# **Staff Report - Western Weber Planning Commission**

Application Information								
Application Request:	Consideration and action on a request for design review approval of the Weber Storage Sheds located at approximately 1957 North Rulon White Blvd., in the Weber Industrial Park.							
Type of Decision:	Administrative							
Applicant:	ARKA Monterey Park LLC. John Hansen (Representative) & Genneva Blanchard (Project Manager)							
File Number:	DR 2021-05							
Property Information								
Approximate Address:	1957 North Rulon White Blvd., Oden, UT							
Project Area:	3.26 Acres							
Zoning:	M-1							
Existing Land Use:	Vacant							
Proposed Land Use:	Commercial Indoor Personal Storage							
Parcel ID:	19-174-0001							
Township, Range, Section	Township 7 North, Range 2 West, Section 36 SE							
	Township 6 North, Range 2 West, Section 1 NE							
Adjacent Land Use								
North: ARKA Montere	y Park South: KBR Roofing							
East: Kimberly Clark	West: Water Storage Pond

The Planning Division recommends approval of file #DR 2021-05 subject to all review agency requirements and the following conditions:

# PLANT SCHEDULE

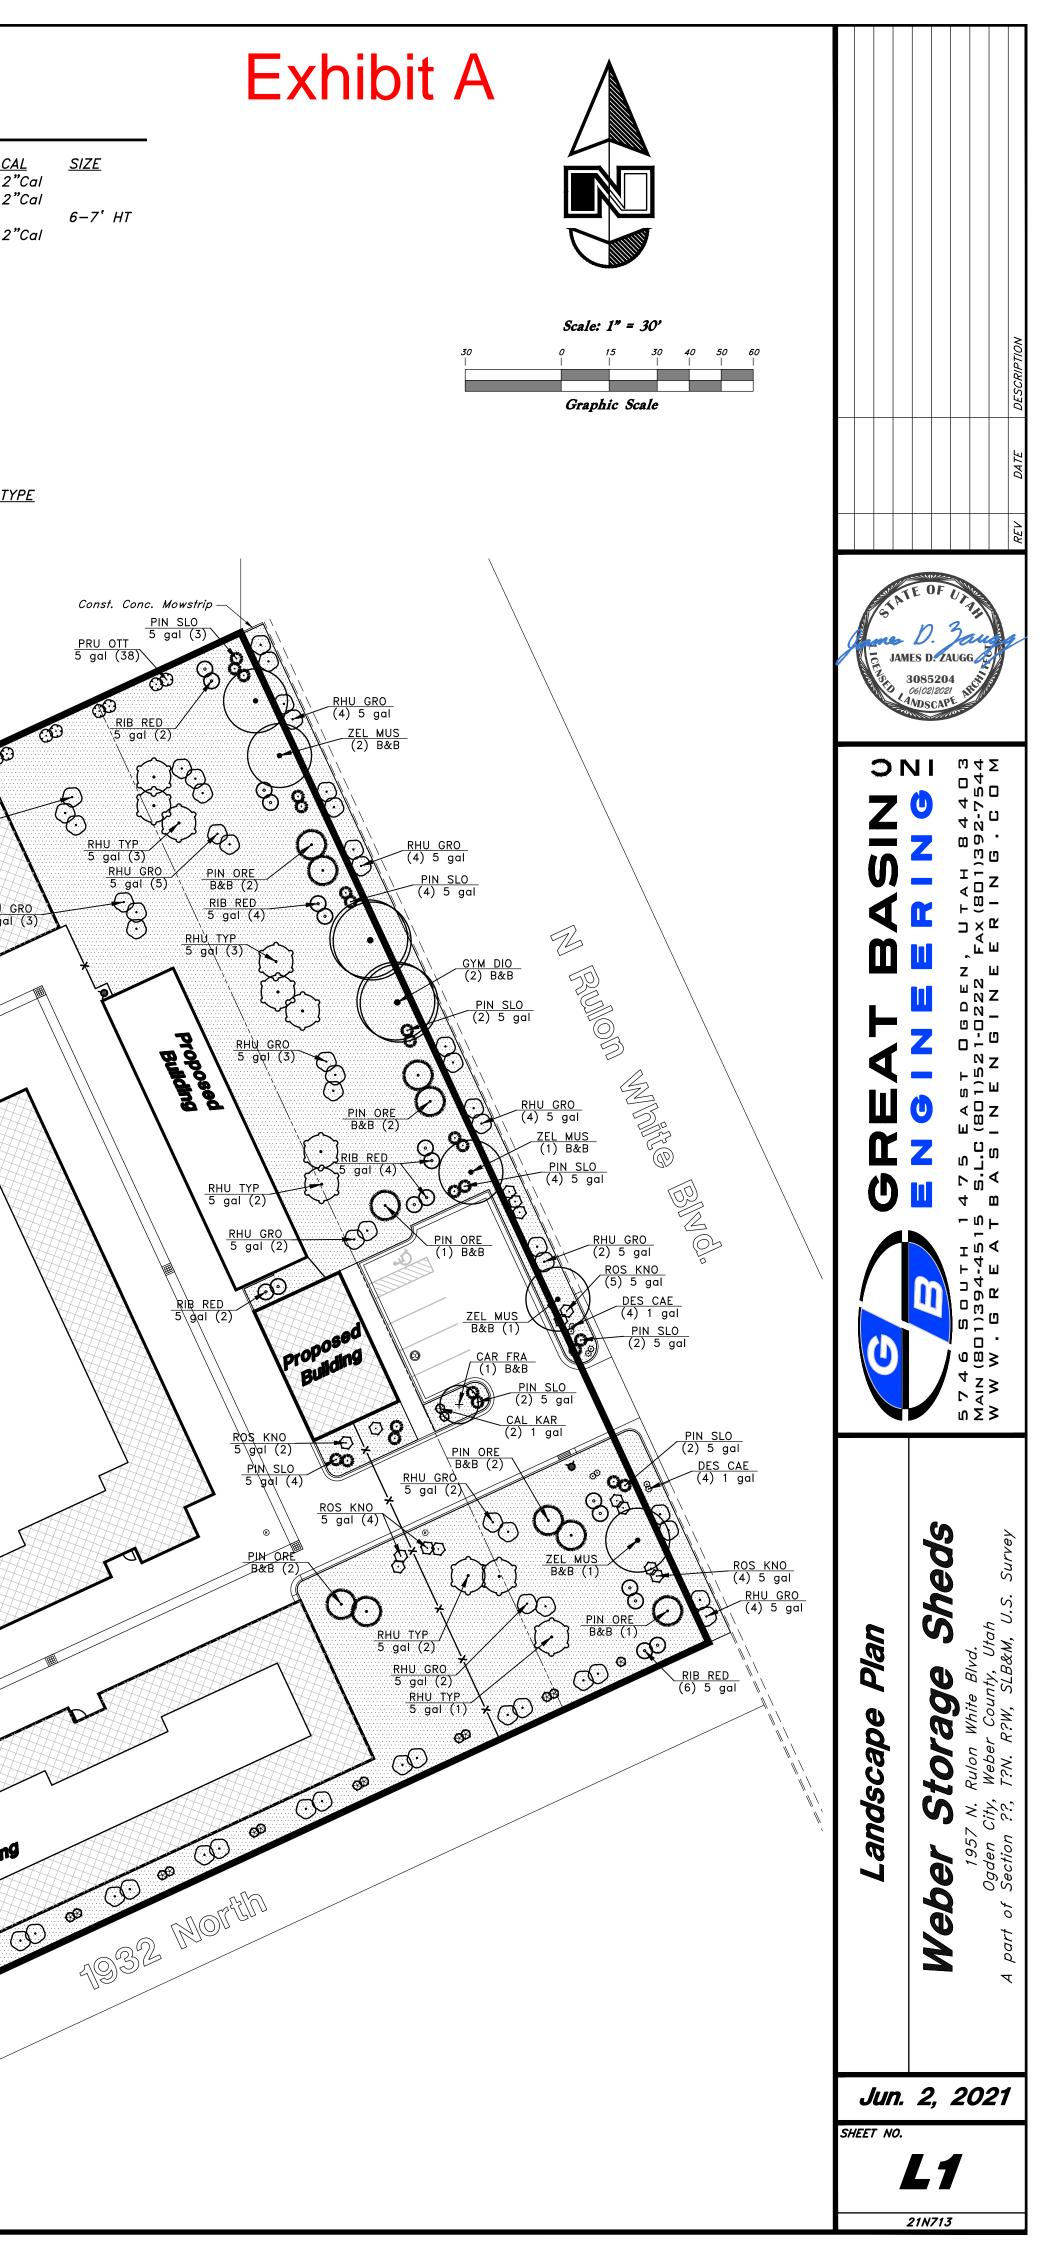
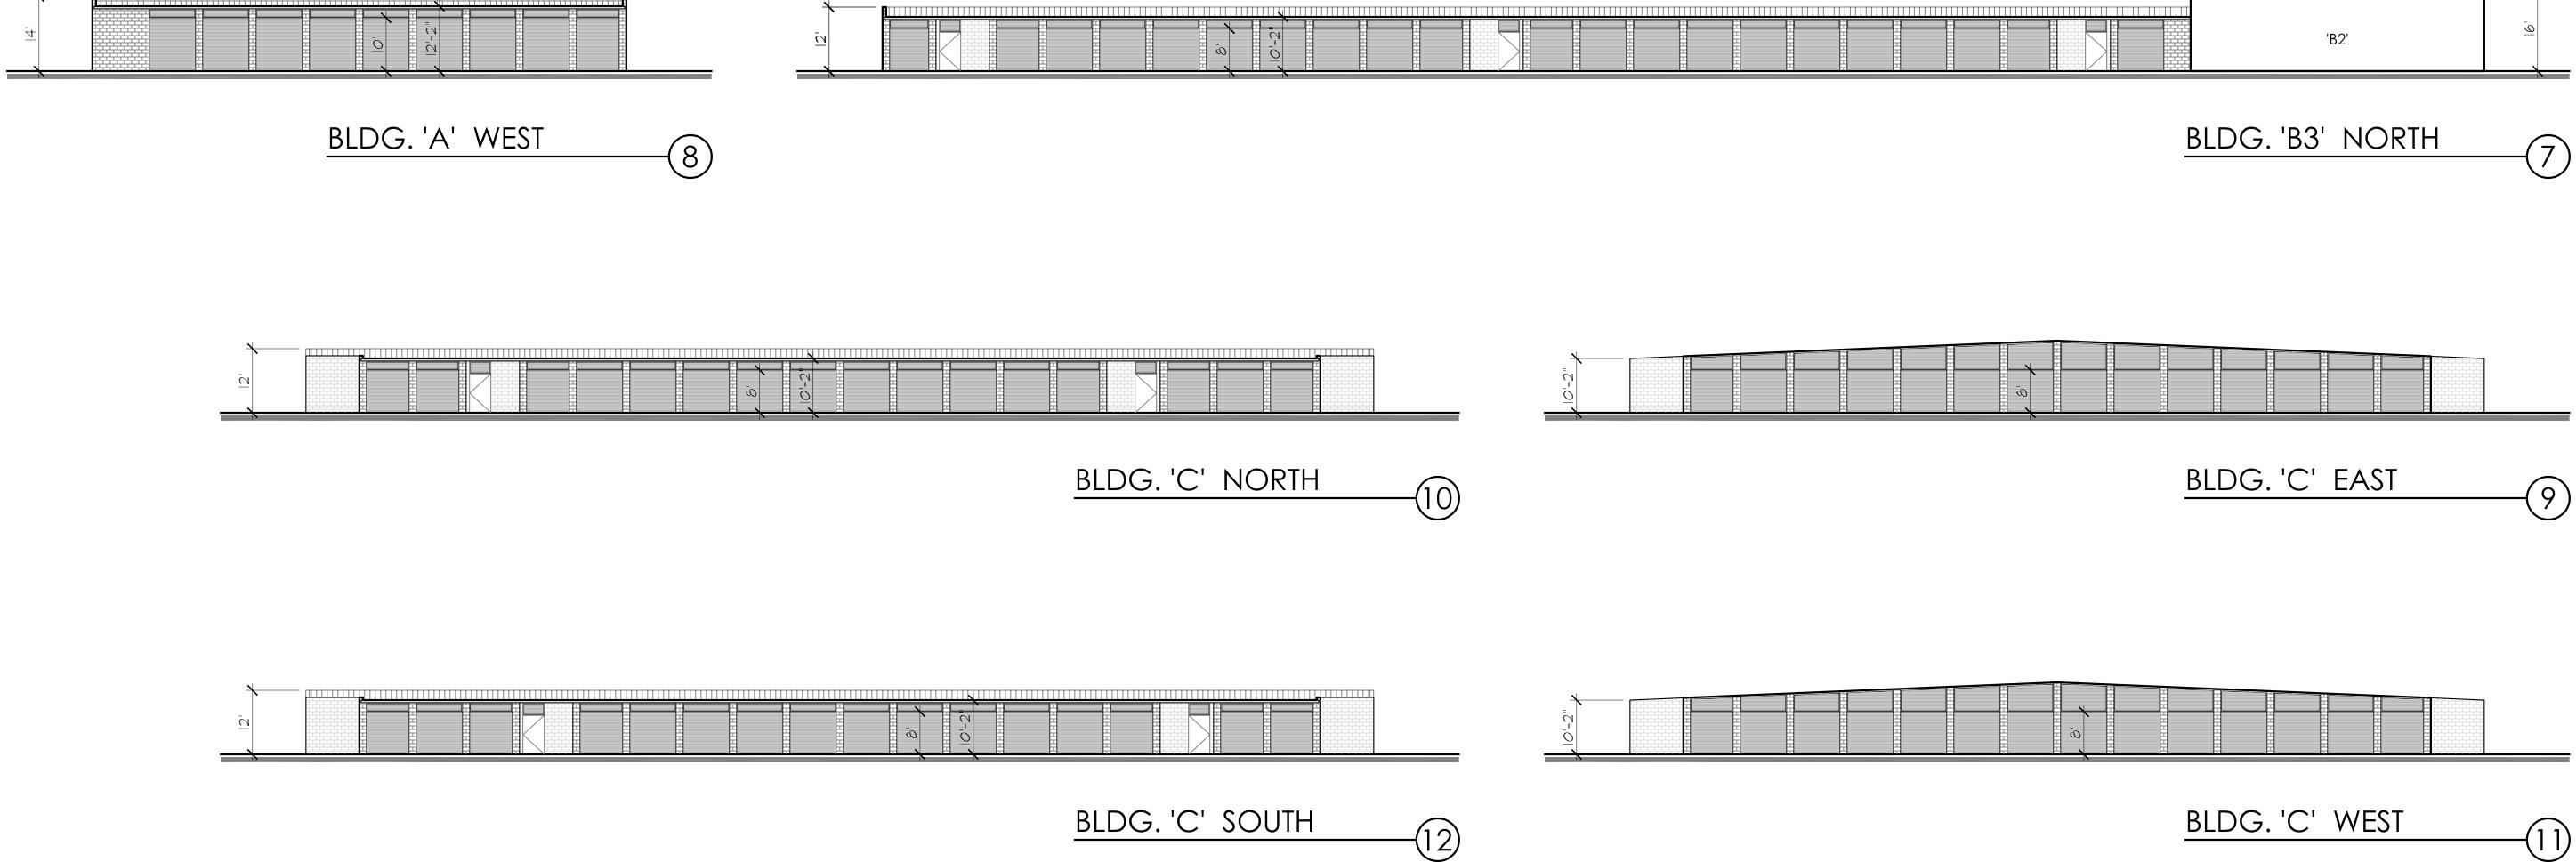
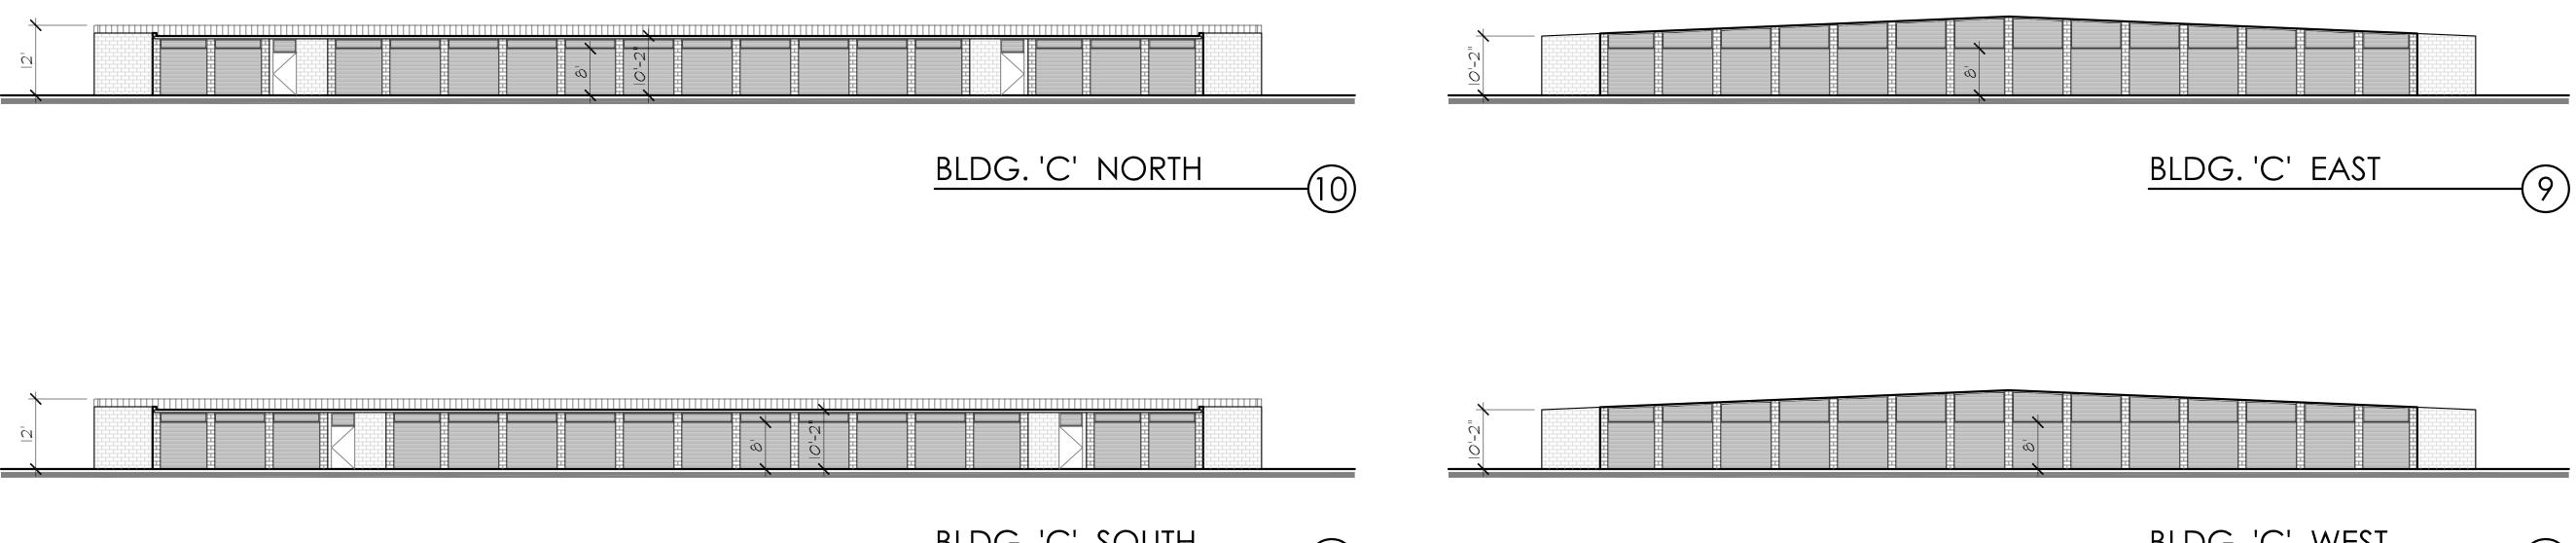
- Planning staff believes that more robust and taller plantings could help to break up the long and monotonous facades along the side lot lines of the development. The zero setback proposed along the rear lot line backs up to an existing detention pond/basin. As such, the rear façade is less of a design concern.

- As a recommendation, staff would like to see an updated landscaping plan to address this concern. However, the applicant has indicated that they will be updating their landscaping plan accordingly and will bring the updated plan to the Planning Commission meeting for consideration.

- 1. An updated landscaping plan shall be submitted that explores the use of more robust and taller plantings along the side lot lines to help break up the long and monotonous building facades.

<u>BLDG. 'B3'</u>	OFFICE

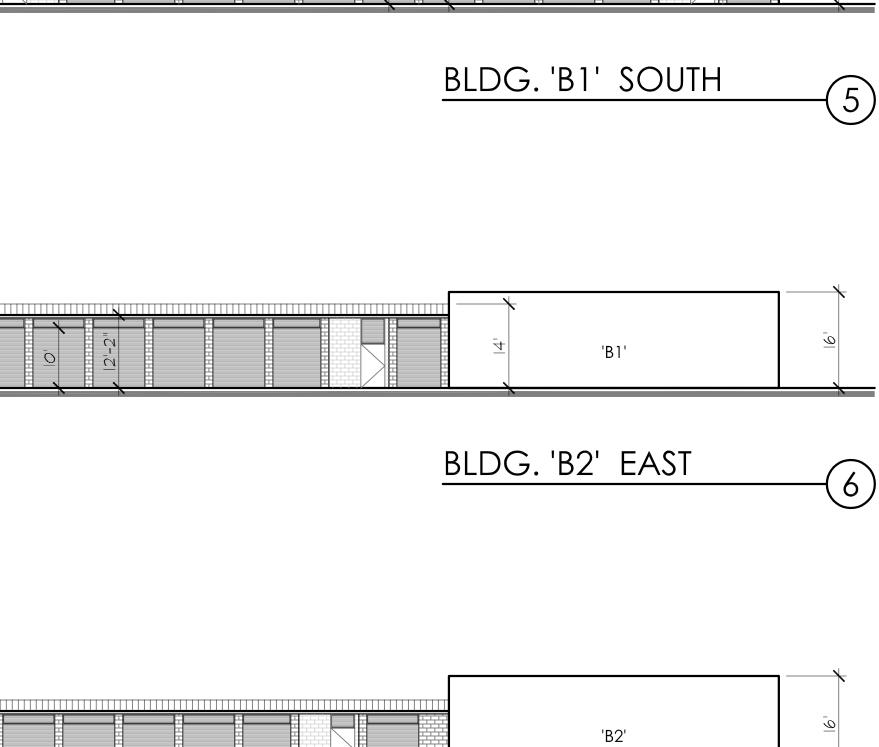
- As a condition of approval, staff recommends that the applicant submit a more detailed architectural elevation of the leasing office. However, the applicant has indicated that they will bring an updated elevation plan to the Planning Commission meeting for consideration.

- 2. The applicant shall submit a formal color pallet and materials board for review by the Planning Commission.
- 3. The applicant shall submit a more detailed architectural elevation of the leasing office for review by the Planning Commission.
